**CITY OF CARMEL-BY-THE-SEA  
PLANNING COMMISSION  
REGULAR MEETING AGENDA**

September 10, 2014  
Wednesday  
Tour – 2:30 p.m.  
Meeting – 4:00 p.m.

Planning Commission Report

**PROPOSED SITE PLAN**  
**MAKLER RESIDENCE**  
SANTA LUCIA AVE & CASANOVA ST  
CARMEL BY THE SEA, CA  
APN: 010-176-025

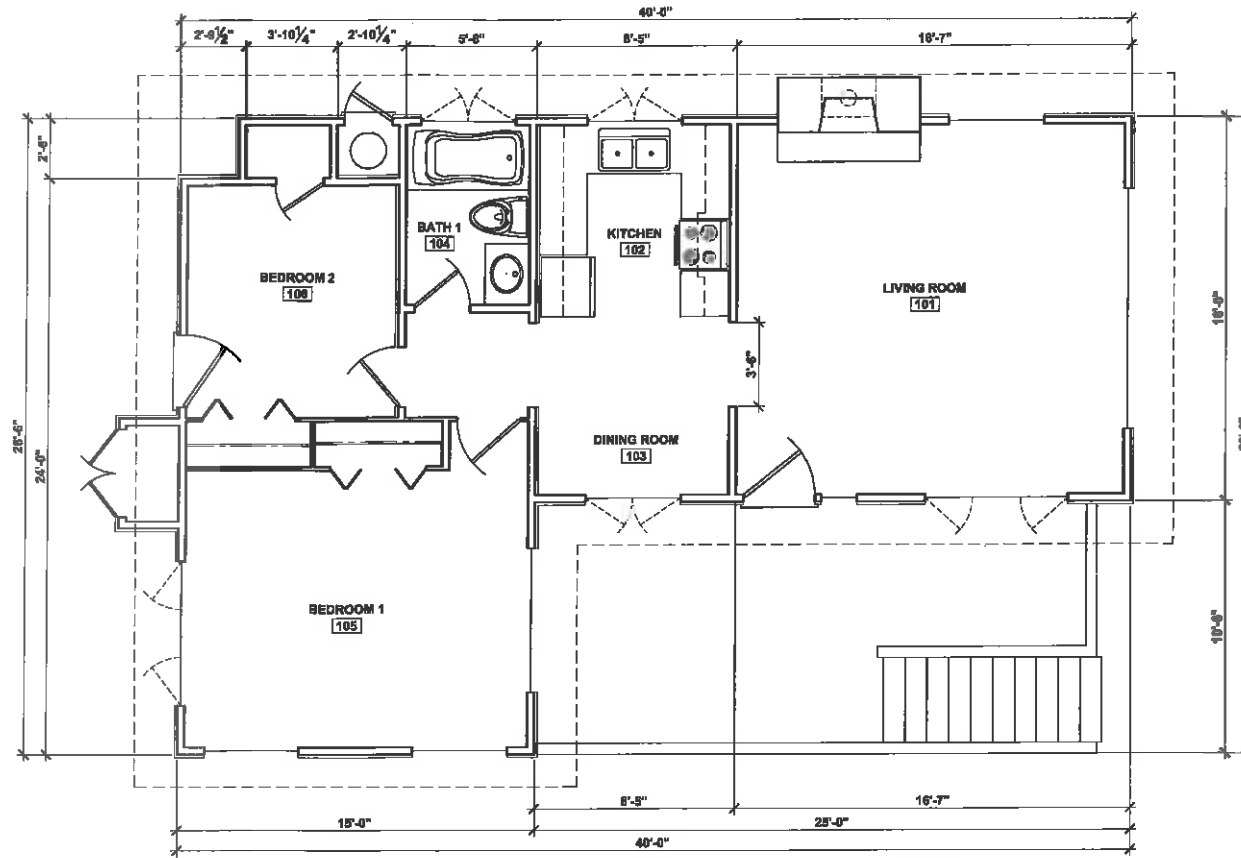
1. *The applicant shall submit a landscape plan for final Planning Commission review that includes one new upper-canopy tree on the site.*

**Analysis:** The applicant is proposing to maintain the existing landscaping, as shown in the site photographs included in Attachment A. The site plan on Sheet A-1.2 of the plan set indicates that one new upper-canopy Monterey pine tree will be planted at the rear of the property.
